AGENDA
PLANNING AND ZONING COMMISSION MEETING
CITY OF CREVE COEUR, MISSOURI
MONDAY, MAY 7, 2018
6:30 PM

NEW BUSINESS**1. PUBLIC HEARING. Application #18-018: Boundary Adjustment Between 4509 And 10725 Baur Boulevard, And Site Development Plan And Conditional Use Permit For Schaefer Auto Body Center At 4509 Baur Boulevard**

**APPLICATION TO PLANNING AND ZONING COMMISSION
#18-018: BOUNDARY ADJUSTMENT BETWEEN 4509 AND 10725 BAUR
BOULEVARD, AND SITE DEVELOPMENT PLAN AND
CONDITIONAL USE PERMIT FOR SCHAEFER AUTO BODY CENTER
AT 4509 BAUR BOULEVARD**

Figure 2: Close-up of the proposed South Elevation

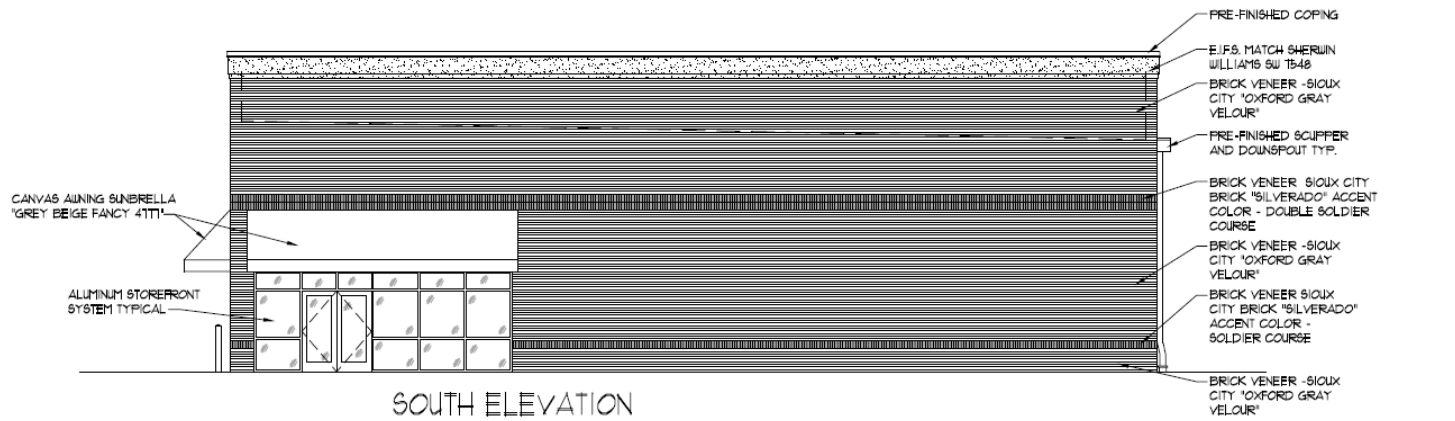
The proposal includes a brick front for the office area with a grey smooth CMU for the work area. A column detail has been provided to create a natural break in the material of the office area to the smooth faced CMU, and to break up the roof line. The smooth faced CMU is inconsistent with the Design Guidelines which recommends the use of split faced block. While the brick is not carried on all elevations, that is something that is found throughout the LI District, and given the character of the area and the functional use of the building, Staff finds the transition of materials on the building to be acceptable. However Staff does have a concern on the use of the smooth faced block and the overall color scheme. Therefore, Staff has included a condition of approval that the smooth faced CMU shall be revised to a split faced materials, and a consistent color with the front of the building. The Commission should review and discuss the material options with the Applicant and provide direction during the meeting.

4. The Elevations shall be revised to include a split faced material and a color consistent with the brick on the front of the building.
5. All activity and storage of parts and other materials shall occur within the building or fenced area.

Figure 5: Close-up of the proposed Landscape Plan

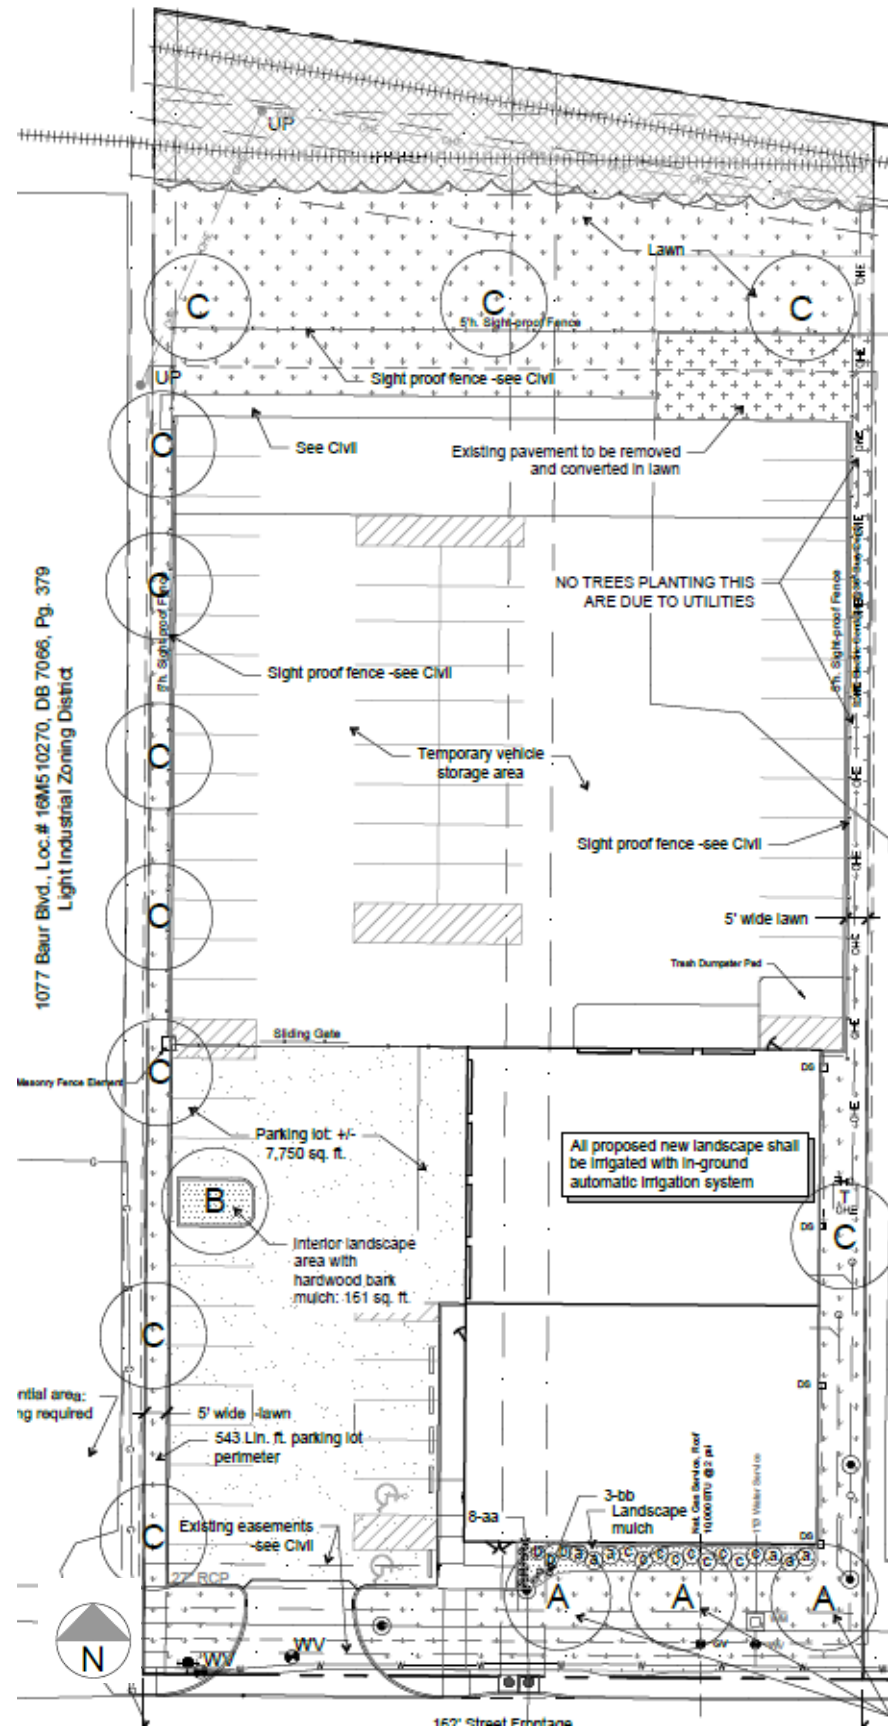
The proposal includes landscaping in front of the building and trees along all property lines, to break up the fence line, and that all landscaping will be maintained with a underground irrigation system, per the requirements of Section 405.540 Landscaping of the Zoning Ordinance. While the Concept Planting Plan does not specifically identify plant material, a condition of approval includes that the final landscape plan will need to comply with Section 405.540(13) that no plants that that are known to be invasive shall be permitted.

7. A final landscape plan shall be provided to comply with Section 405.540 Landscaping for the Zoning Administrator's approval.
8. A minimum 5 foot landscaped buffer shall be provided along both sides of the property line with 10725 Baur Boulevard.

Figure 7: Close-up of Landscape Plan along Baur Boulevard.

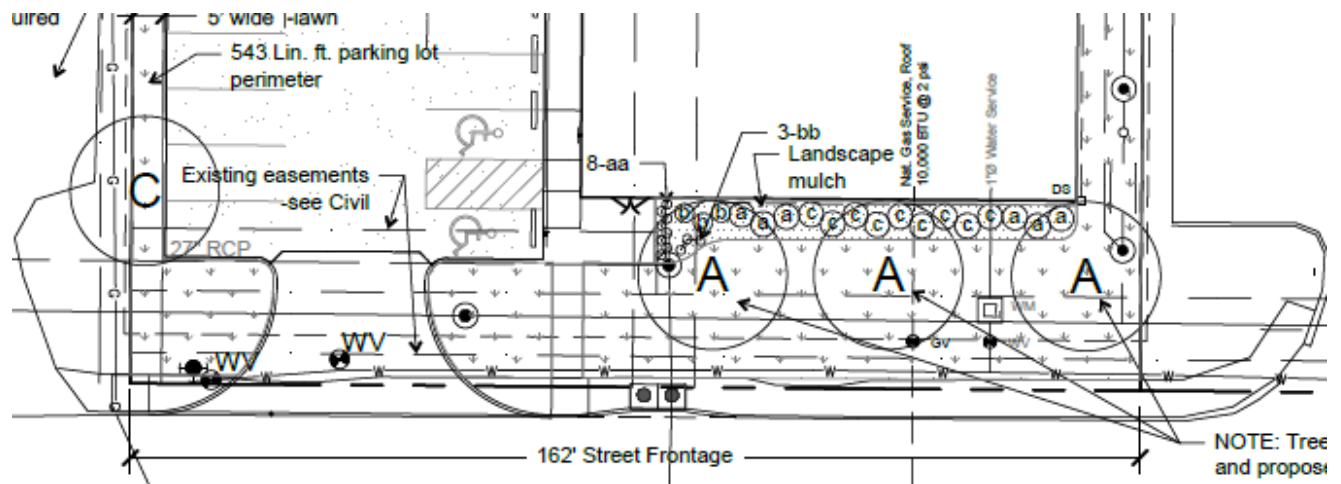
Staff has included a condition of approval that a minimum of a 5 foot landscaped buffer shall be provided for the property at 10771 Baur Boulevard with the boundary adjustment, where there is existing concrete.
